Service Kit

753-05851

Subject: Service Replacement for the
618-04034 Single Speed TransmissionModels N/A
Affected:

Subject: Torque Bracket Rework

FIGURE 2

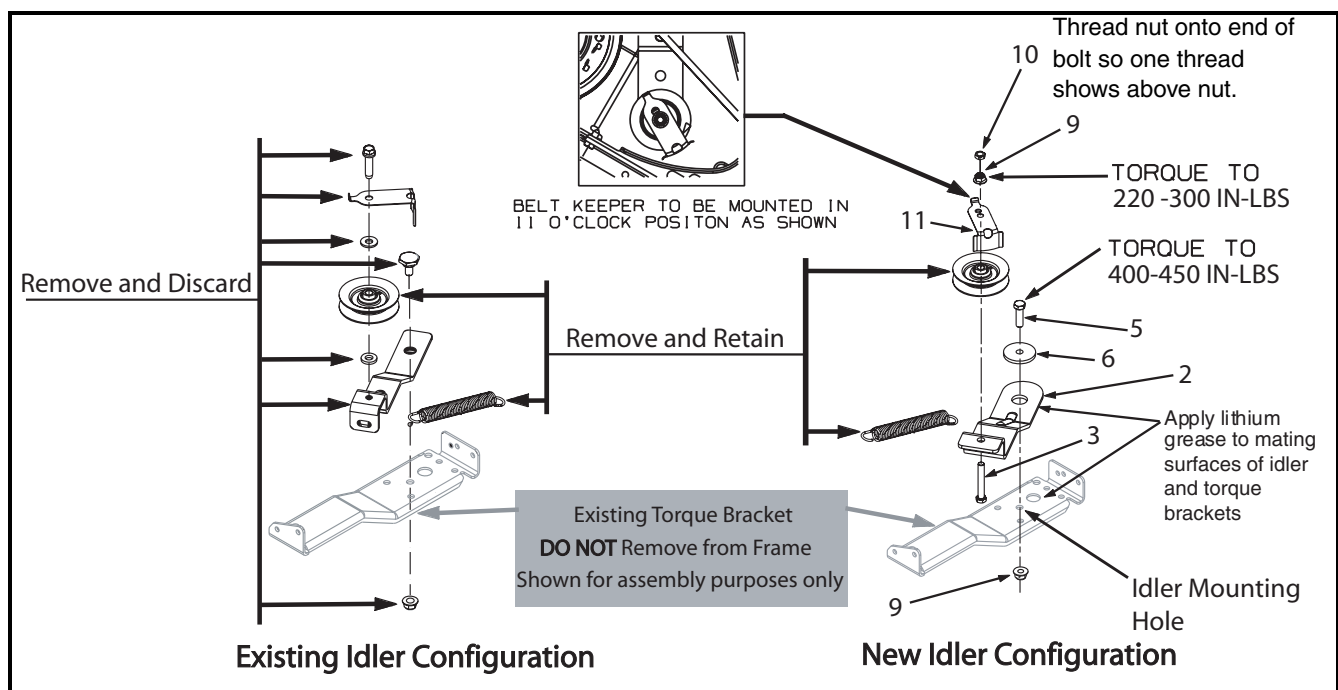
12. Inspect the existing idler bracket configuration. Referring to Figure 2, if the existing idler bracket is similar to that shown in the **Existing Idler Configuration**, proceed to Step 13.

If the existing idler bracket configuration is similar to that shown in the **New Idler Configuration**, the idler bracket and spring mount have already been installed. STOP HERE.

14. Refer to Figure 2. Following the instructions within Figure 2, re-configure the upper transmission drive belt idler assembly as shown by the New Idler Configuration using the new hardware supplied and that retained as instructed.

NOTE: Ensure that the upper transmission drive belt is installed around the idler pulley before mounting the belt keeper. DO NOT install the idler's tension spring at this time.

FIGURE 1

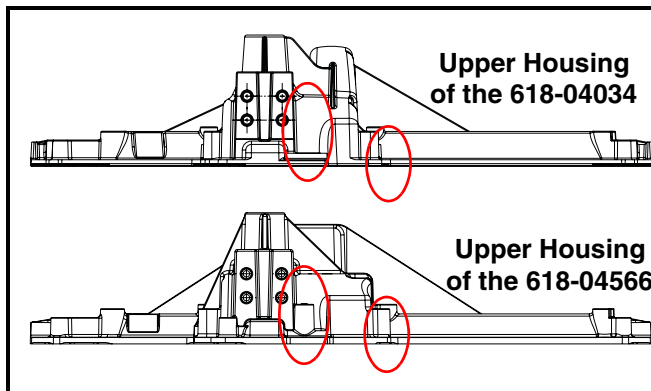
The configuration of the upper housing of the new 618-04566 transmission (See Figure 1) will interfere with the cross member torque bracket at two points. This results in the transmission not seating onto the frame at its mounting points.

1. Lawn tractor is a 600 Series AutoDrive, Transmatic or Shift-On-the-Go (non-hydrostatic transmissions) model
2. The existing transmission, being replaced, is a single speed 618-04034. See area of concern in Figure 1.
3. The existing torque bracket is a full side-to-side cross member style as shown in Figure 2.

FIGURE 2

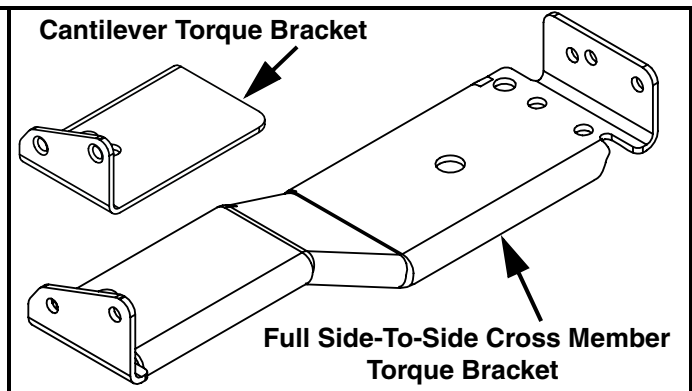
PURPOSE: This supplement sheet provides the rework instructions, if required see below, for the side-to-side cross member torque bracket when replacing the **618-04034** transmission with the service replacement **618-04566** supplied in the **753-05851** service kit. No rework of the torque bracket is required if the torque bracket is of the cantilever style (see Figure 2).

FIGURE 3

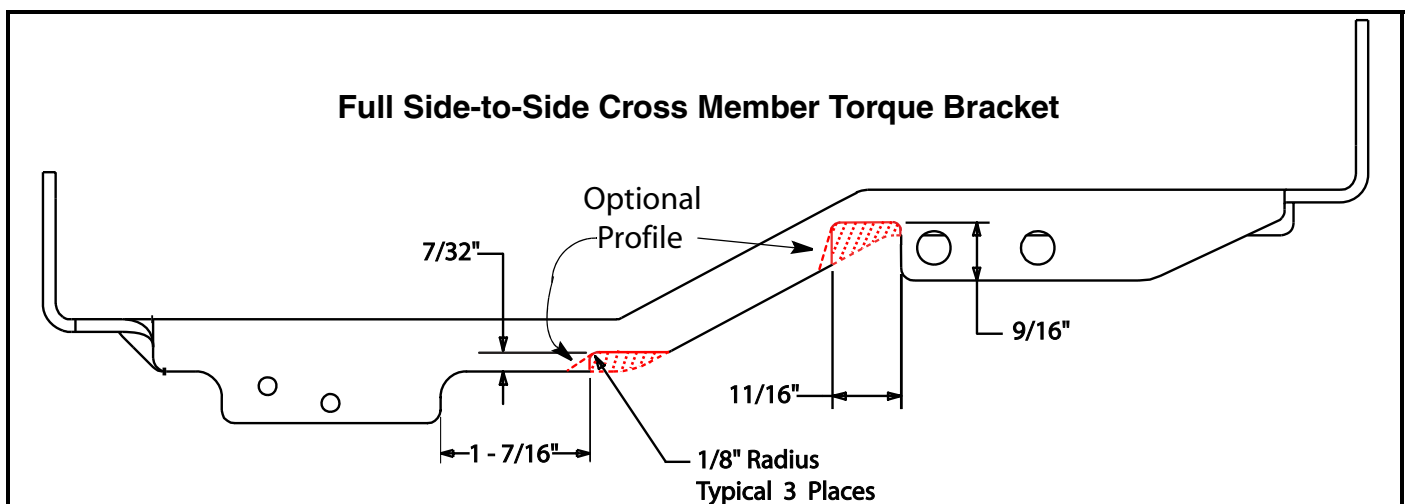
1. With the transmission removed from the lawn tractor, mark the cross member as shown in red in Figure 3.

2. Using a 4-1/2" hand held angle grinder with a 4" abrasive cutoff disk, remove the torque bracket material shown in red in Figure 3. Remove the material slowly so as not to over heat the part.
3. Remove any burrs or sharp edges with a file. Use a primer/sealer to cover the exposed metal.
